# Assessment of proposed lighting plan for Roundhouse Parking Lot, Northampton, MA

Prepared by Northampton City Lights

May 20, 2021

Figure 6: Light pollution map showing sky glow in the Northampton area. The night sky over downtown is 6x brighter than the naturally dark sky; the Milky Way and 80% of naturally visible stars are invisible. (Source: <https://www.lightpollutionmap.info/>)

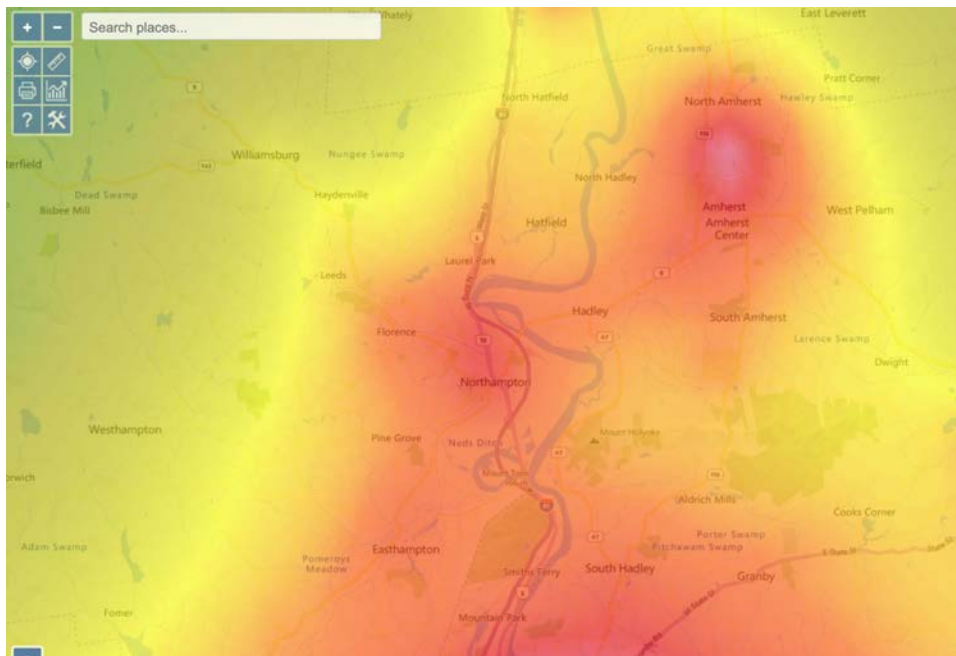
The proposed fixtures have zero direct uplighting, but their high-blue content (3000K), their high intensity, and their poor shielding from glare mean that they would be a **significant new source of light pollution and sky glow**. Of the light that is directed where it should be directed – straight down – roughly 30% reflects off pavement into the sky, where it scatters off aerosol particles to create artificial sky glow. Worse, the light escaping sideways from the fixtures – also associated with glare and light trespass -- can potentially travel for even greater distance in the atmosphere, perhaps many miles, than direct uplighting, and is likely an even greater source of skyglow.
